Access Compliance Report

Public Rights-of-Way

(Curb Ramps)

Intersection ID: 22977	Main Street: SOUTH_BV	Cross Street: MUSTANG_LN	Location: SE
ADA ID: E59EA0E4DC71	Ramp Type: Perp	Initial Pass/Fail: Fail	Overall Compliance: No
Severity Score: 21.25			
Codes/Mitigation Info/Possible Solution		Field Measurements/Component Compliance

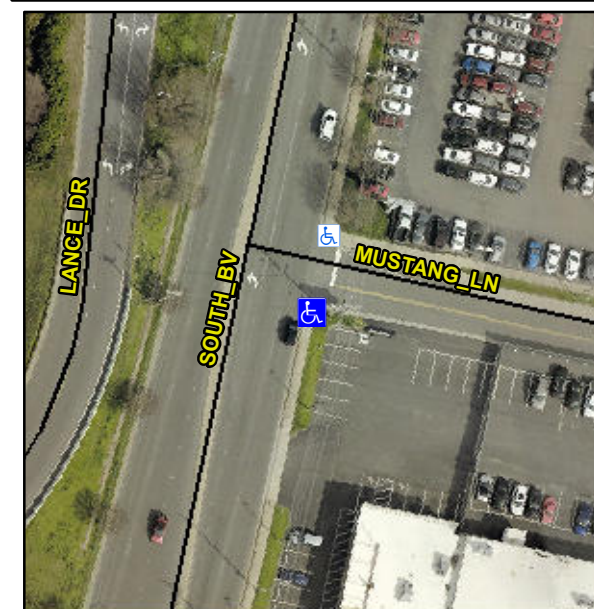
Not Found, R304.5.1, R304.5.3

Compliance	Description	Data	Compliance	Description	Data
N/A	Ramp Length (in)	60.0	Yes	Ramp Slope (%)	6.5
No	Ramp Width (in)	47.5	No	Ramp XSlope (%)	6.3
N/A	Flare Type LT	N/A	N/A	Flare Type RT	N/A
N/A	Flare Slope LT (%)	N/A	N/A	Flare Slope RT (%)	N/A
N/A	Flare Traversable LT?	N/A	N/A	Flare Traversable RT?	N/A
N/A	Landing Length (in)	N/A	N/A	DWS Provided?	N/A
N/A	Landing Width (in)	N/A	N/A	DWS Contrast?	N/A
N/A	Landing Slope (%)	N/A	N/A	DWS Length (in)	N/A
N/A	Landing X Slope (%)	N/A	N/A	DWS Full Width?	N/A
N/A	Landing Curb? (Y/N)	N/A	N/A	DWS Offset (in)	N/A
N/A	Shared Landing?	N/A			
N/A	Gutter Ponding?	N/A	N/A	Gutter Slope (%)	N/A
N/A	Gutter Lip Ht (in)	N/A	N/A	Gutter X Slope (%)	N/A
N/A	Painted X Walk1?	No	N/A	Painted X Walk2?	N/A
	X Walk 1 Direction	To N		X Walk 2 Direction	N/A
N/A	X Walk 1 Width (in)	N/A	N/A	X Walk 2 Width (in)	N/A
	X Walk 1 Slope (%)	0.6		X Walk 2 Slope (%)	N/A
	X Walk 1 X Slope (%)	1.4		X Walk 2 X Slope (%)	N/A

Remove & Replace Entire Ramp.
